LiDAR QA/QC
- Quantitative and Qualitative Assessment Report -
Gloucester County
December 4, 2007

Prepared by:
 **Dewberry**
Fairfax, VA

Figure 20 – tile 295_360. Cornrows under the acceptable limit (0.5feet)

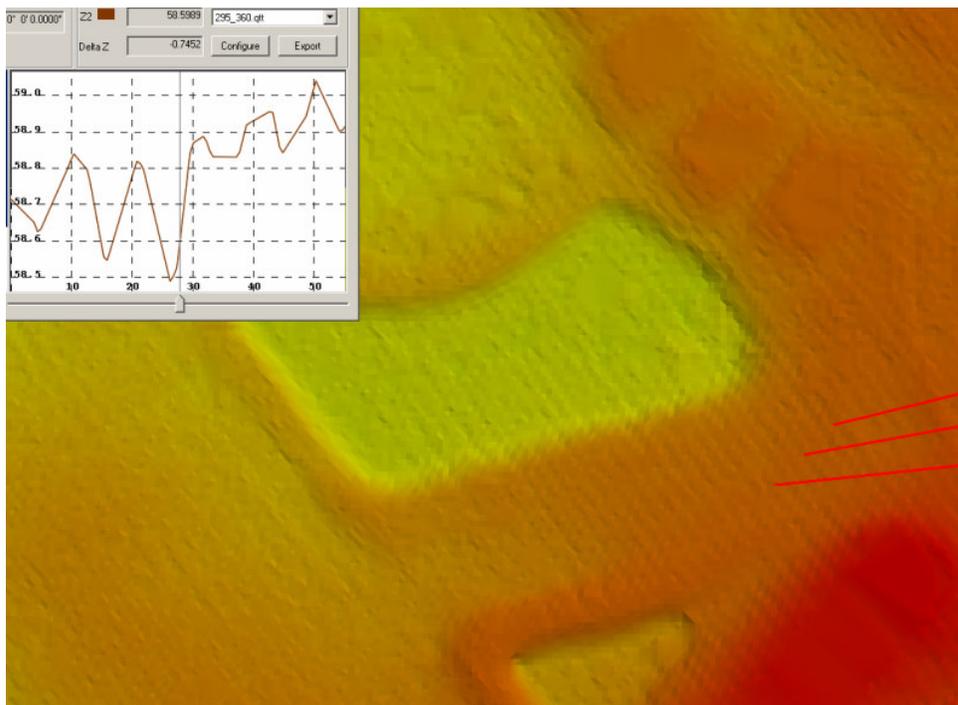
Cornrows were typically seen throughout the project. There are multiple reasons as to why this happens but the end result is that adjacent scan lines are slightly offset from each other. This will give the effect that there are alternating rows of higher and then lower elevations. Although this is common with LiDAR data, as long as the elevation differences are less than 20 cm and the occurrences are minimized, it is acceptable because it is within the noise and accuracy levels. However this also can be an indication that the sensor is mis-calibrated, or offsets exist between adjacent flight lines so each area identified is analyzed. Our review found several negligible instances of the cornrow effect however only two or three were significant (see for instance Figure 20) and the remainder of this effect was within acceptable limits.

Figure 21 – Tile 300_370: inconsistent Bridge editing. Bridges are sometimes removed, totally retained or sometimes portions of the bridge remain in the bare earth terrain.

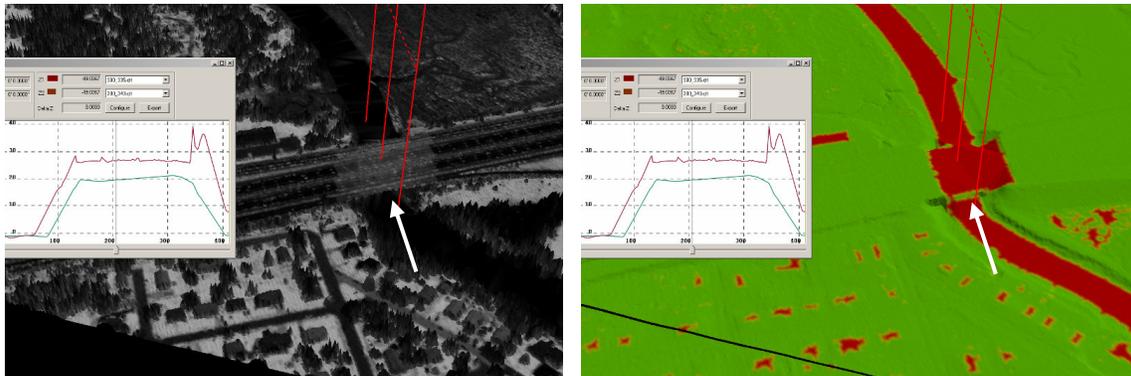
One minor issue for the bare-earth terrain is the classification of bridges.. Some users may require bridges to be removed (classified to non-ground) while others may require them classified as ground. For the user community if this is an issue this is easily remedied because it is clearly identifiable and the data can be reclassified. In this dataset, the majority of them are removed from the ground but some instances of bridges partially removed were found. *Figure 21* illustrates this case..

Figure 22 – Tile 240_350: possible human artifact in bare-earth model

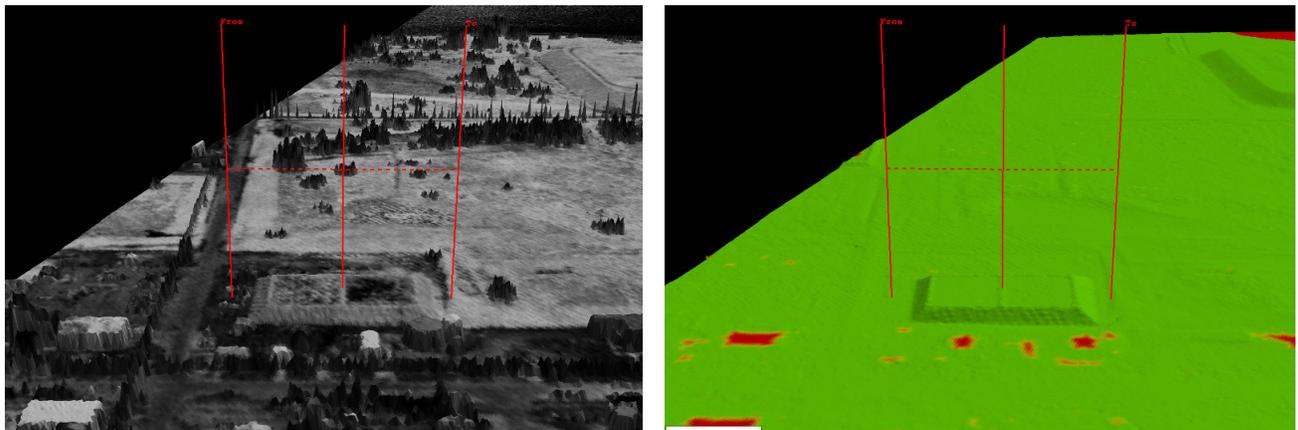
Due to the vast amounts of data and geographic phenomena, the classification algorithms can sometimes erroneously classify data. This misclassification results in artifacts which can be remnants of vegetation or manmade structures that do not represent the bare-earth terrain. *Figure 22* illustrates potential artifacts based on the visual inspections of the bare-earth terrain. None of these tiles have been ground-truthed and therefore are identified only as potential issues. Moreover, it is evident that these potential areas are relatively small and easily within the specification of being 95% cleaned of artifacts.

Figure 24 - Tile 487500_4663500: Lidar points. Note the variation in point spacing between scans inside a same flightline.

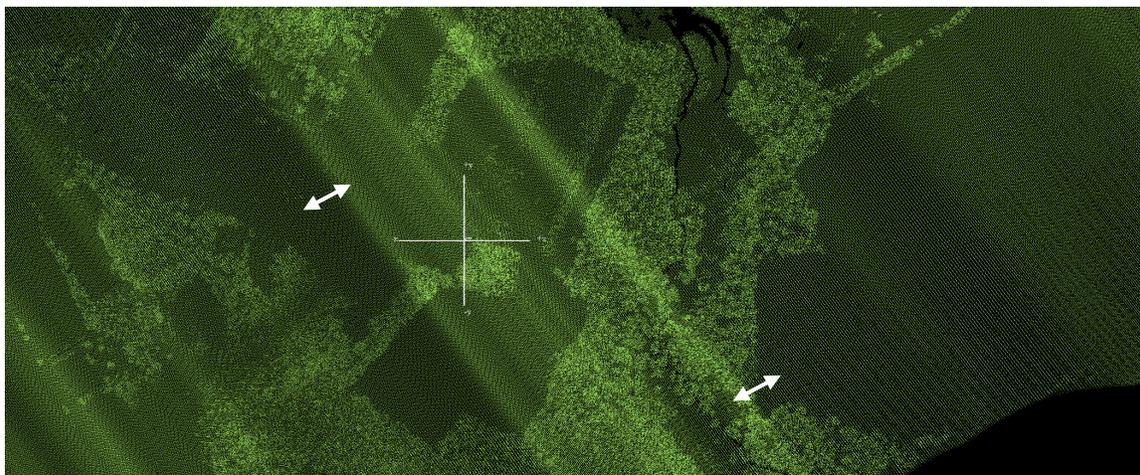
Sometimes scan pattern can vary along a flight line due to windy conditions or due to mirror acceleration. *Figure 24* shows a tile with large variations. Note however that the point spacing along the scan line conform to the requirements. This type of irregular scan is recurrent but does not compromise the integrity of this data.

Figure 25 – Poor LiDAR reflection in swamp area, the cross section and the full point cloud show the presence of vegetation but the Lidar do not seem to be reflected by the underlying surface.

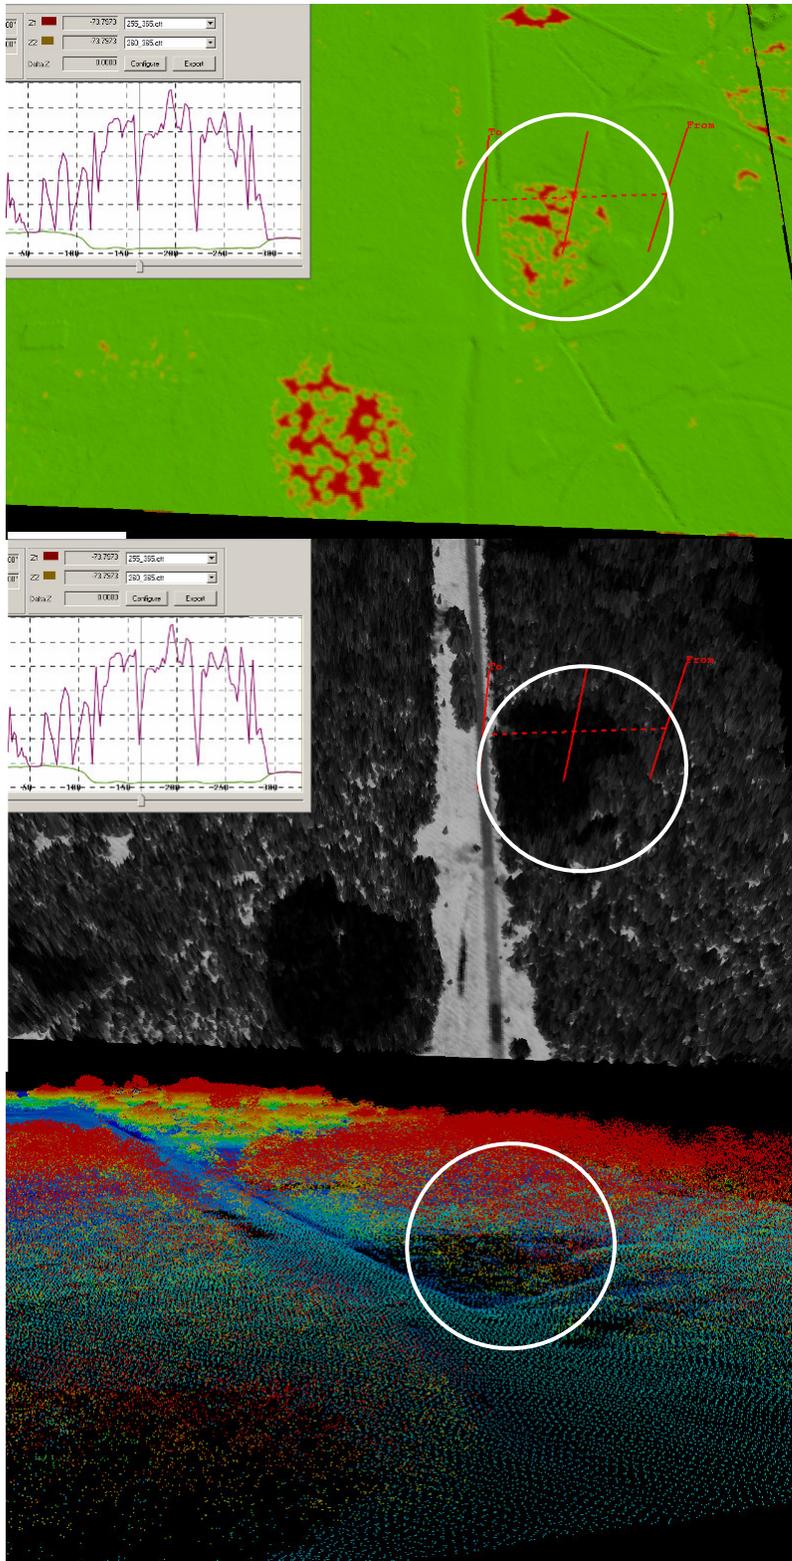
We did find some isolated spots of sparse density of points in the bare earth model with no apparent change in the vegetation density at these locations; however the intensity image is characterized by a darker tone. After carefully inspecting the full point cloud, which really shows presence of Lidar points inside the vegetation but very few at ground level and based on the dark coloration of the intensity images we assumed that these are swamp areas where the Lidar is not reflected by the wet ground surface. Indeed, except at angles close to nadir, the Near Infrared Lidar beam is usually not reflected by water.

Figure 26 – Islands classified as water (tile 250_350)

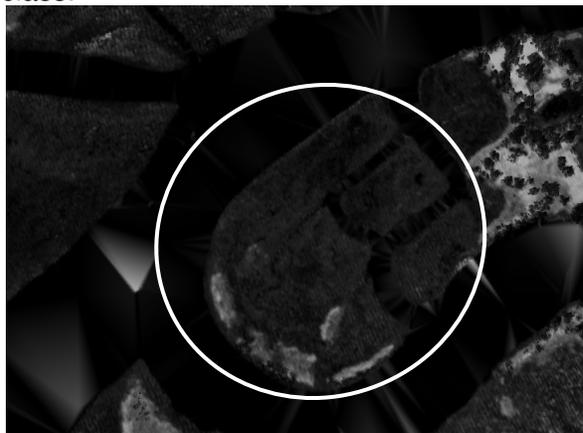
In addition, users should be aware that the contract for acquisition and processing identified only two classes: Class “1” for unclassified and Class “2” for ground. However Terrapoint did classify water points in a separate category using breaklines developed with the intensity images. Globally the classification of water was satisfactory. We found few instances of ground points wrongly classified as water, mainly islands or sand bars (see example in *Figure 26*). In addition, some sections of water bodies remained in the ground class, most of the time they were portions of rivers looking like salt and pepper noise in the intensity image as illustrated in *Figure 27*.

Once again, as the classification of water was not required in the scope of work, this is not something we consider as an issue, the end user should just be aware that further processing may be needed to completely remove the water points from the ground class.

Figure 28 – Tile 270_315 misclassification of ground

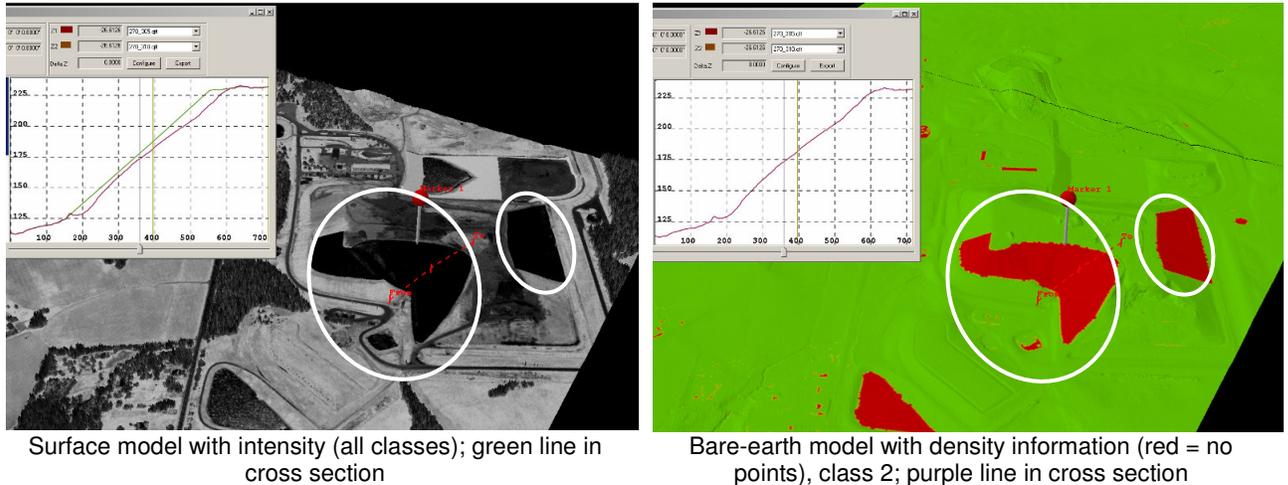
Finally, one occurrence of misclassification of ground was encountered in the data (see *Figure 28*). Two large slope sections of this mine heap are removed from the ground class leaving gaps in the bare earth surface, however the summit of the hill is still there leaving the general surface profile fairly unaffected. Therefore, we do not consider this as a critical issue but users of this data in this area may need to reclassify to suit their intended need and use.
